P98-043 & P98-082 - 1509 T STREET HOUSE MOVE/1525 T STREET  
PARKING LOT

**ATTACHMENT C**  
**NOTICE OF DECISION AND FINDINGS OF FACT FOR**  
**(1509 T Street House Move & 1525 T Street Parking Lot), LOCATED ON 1509 & 1525 T Street**  
**SACRAMENTO, CALIFORNIA IN THE**  
**R-3A & (C-2)[NC] ZONE. (P98-043, 082)**

SITE PLAN AND ELEVATIONS  
SCALE: 1/8" = 1'-0"

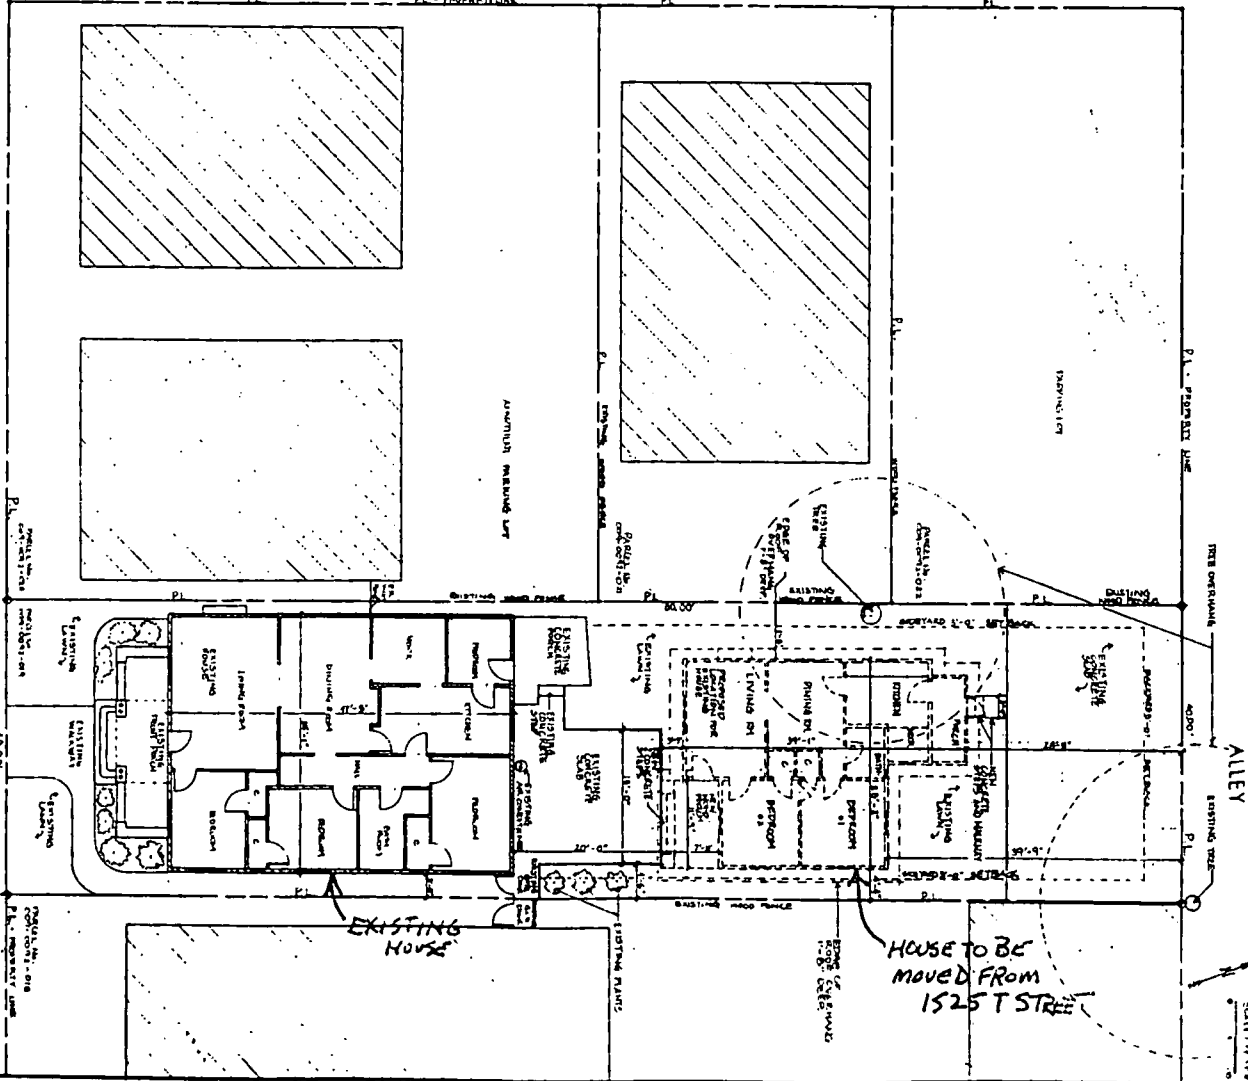
The proposed house move to 1509 T Street will comply with height, setback and lot coverage requirements for the R-3A zone. However, the house move will result in a configuration which does not meet the courtyard requirements of the zoning ordinance. The ordinance states that when a unit has the main entrance from an interior side yard or court, the minimum interior side yard distance shall be ten feet. The existing house in the front of the lot is setback only 3 feet from the property line, making compliance with this requirement infeasible. Although it does not meet standards, the proposed configuration is workable, as the rear unit may be accessed from either the existing 3 foot walkway, from the back door, adjacent to the parking area, or via the 4 ½' or 7' setback areas adjacent to the rear unit. Due to the existing conditions on the site, and due to the feasibility of access in the proposed configuration, staff supports the requested variance to reduce the side courtyard.

The relocation creates a living space with no visibility from the street. 2nd unit addressing must be clearly be marked on T Street.

B1. 2nd unit addressing must be clearly be marked and clearly visible from T Street.

**GRADING PLAN FOR 1525 "T" STREET**  
 CITY OF SACRAMENTO STATE OF CALIFORNIA  
 SHEET 1/1

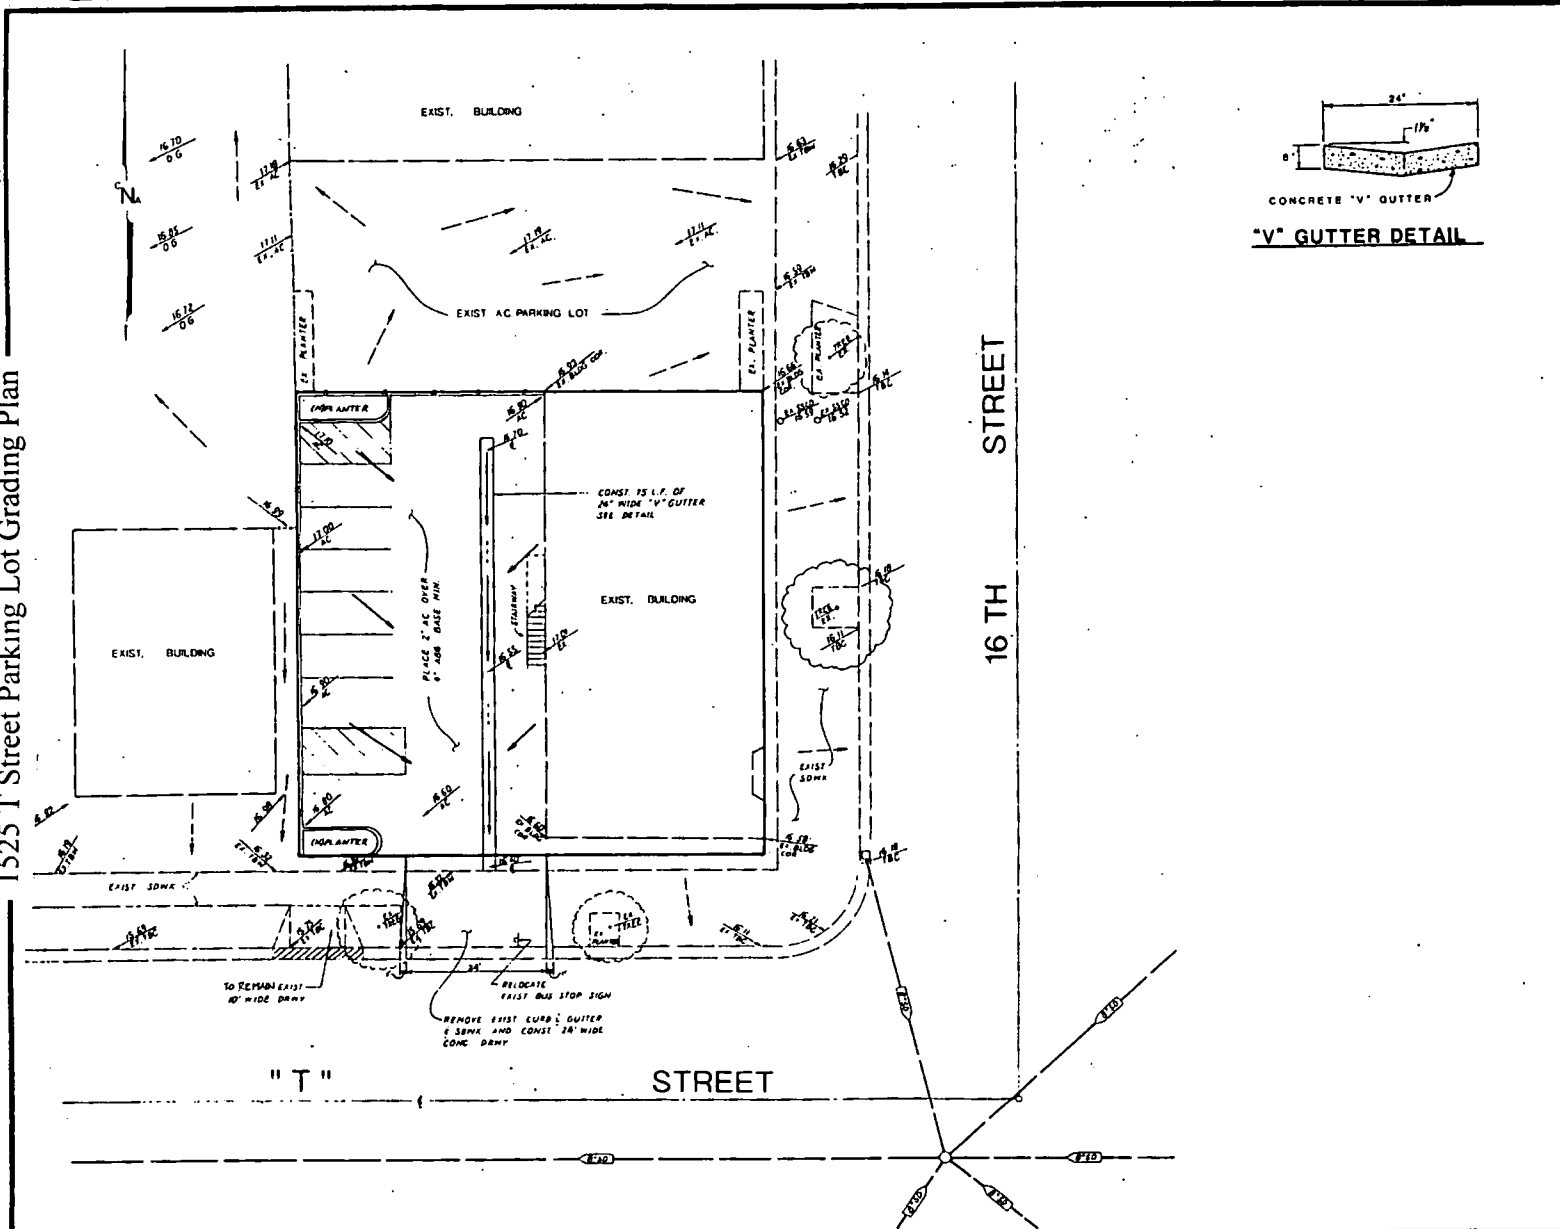
All spaces, with the exception of the handicap space, shall be 8 feet and marked as compact.

A sign shall be placed at the entrance to the parking lot that states "Compact Vehicle Parking Only" or similar.

The planter at the driveway shall be widened 2 feet which will provide adequate maneuvering for the handicap space, as well as providing additional landscaped area.

The striped area to the north of the last parking space shall be eliminated, and the 5 foot planter area at the north of the site shall be increased from 5 feet to 8 feet. This will accommodate the increase width of the parking spaces, provide additional landscaped area, and still provide adequate maneuvering space.

1. Have the lot gated with a rod iron fence.
2. Have the lot only open during hours of store operation.
3. Have automatic sprinklers included in the design of the landscaping.
4. Have the lighting be of the acorn type.
5. Incorporate a waste area in the parking lot to help stop people from throwing out refuse from the back door of the store.

D-H4. All spaces, with the exception of the handicap space, shall be 8 feet and marked as compact.

D-H5. A sign shall be placed at the entrance to the parking lot that states "Compact Vehicle Parking Only" or similar.

D-H6. The planter at the driveway shall be widened 2 feet which will provide adequate maneuvering for the handicap space, as well as providing additional landscaped area.

D-H7. The striped area to the north of the last parking space shall be eliminated, and the 5 foot planter area at the north of the site shall be increased from 5 feet to 8 feet. This will accommodate the increase width of the parking spaces, provide additional landscaped area, and still provide adequate maneuvering space.

D-H9. The applicant shall provide an area for trash storage in the northwest corner of the lot. This area shall have a concrete base and shall be surrounded by chainlink fence with green slats. The planter area immediately surrounding this enclosure shall be planted with vines or ivy.
